**CITY OF BLOOMINGTON  
PLAN COMMISSION AGENDA  
May 6, 2013 @ 5:30 p.m.**

**BLOOMINGTON PLAN COMMISSION  
STAFF REPORT  
Location: 900 S. Basswood Dr.**

**CASE #: PUD-18-13  
DATE: May 6, 2013**

**REQUEST:** The petitioner is requesting site plan approval for a new 54,000 sq. ft. hotel with 84 rooms.

PRELIMINARY NOT FOR CONSTRUCTION  
 SHEET NO. A2.1  
 ELEVATIONS

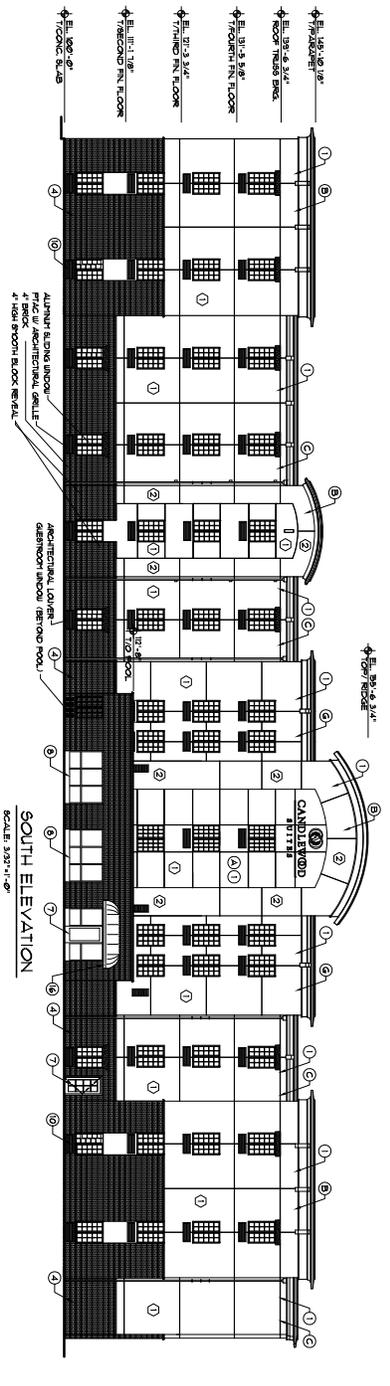
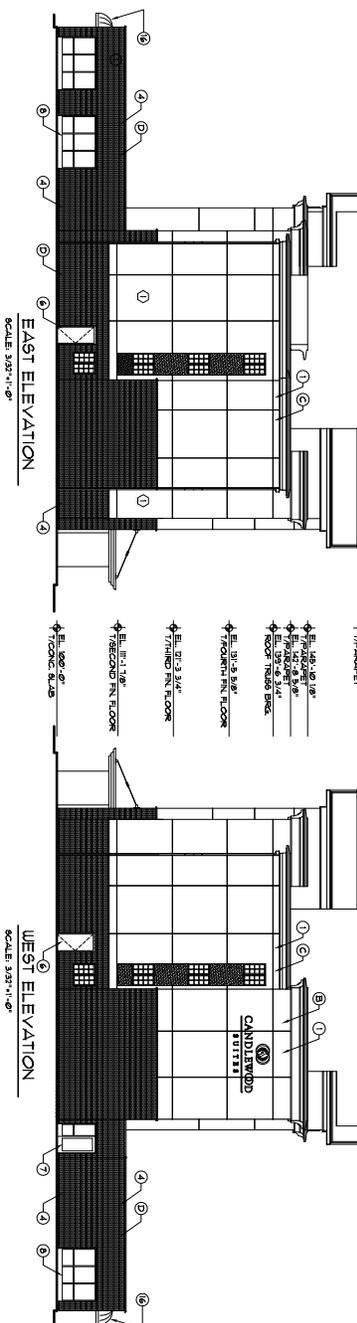
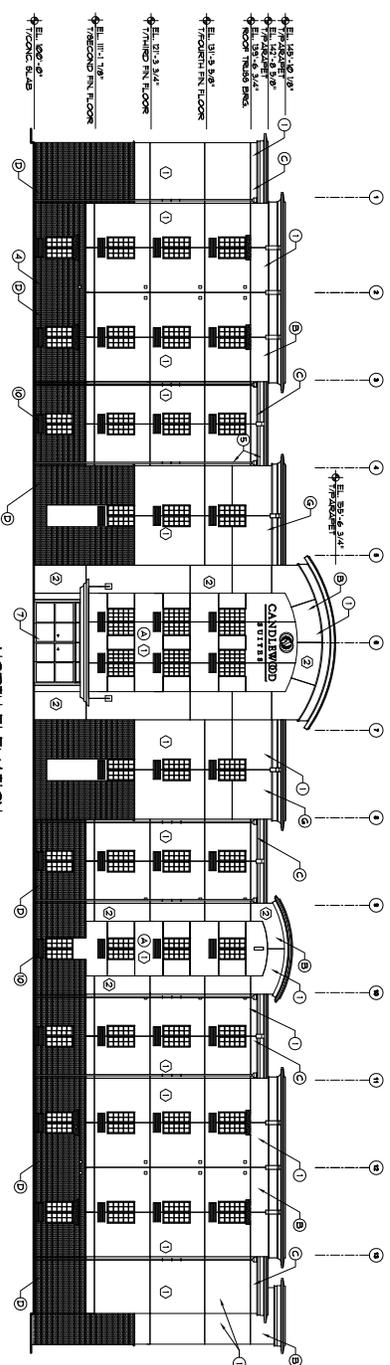
The hotel will have brick and EIFS on the exterior. The location of the hotel and adjacent topography makes the building most visible from Bloomfield Rd. to the south and east and from Basswood Dr. to the west. As a result, Staff requested additional brick along those frontages and the petitioner has increased the amount of brick on

those facades. Staff is seeking guidance from the Plan Commission on whether or not more architectural improvements are needed for the sides of the building visible from the public right-of-way.

**Architecture/Design:** The petitioner has submitted elevations for all four sides of the building and these have been included in the packet. The building will be finished with brick and EIFS. The roof will be flat with a raised parapet to hide mechanicals. The elevations and architecture do meet the standard UDO requirements, however as noted above, Staff seeks guidance from the Plan Commission regarding whether or not additional architectural improvements are needed.

**RECOMMENDATION:** Pending guidance from the Plan Commission regarding the architecture, Staff recommends approval of the proposed site plan with the following conditions of approval:
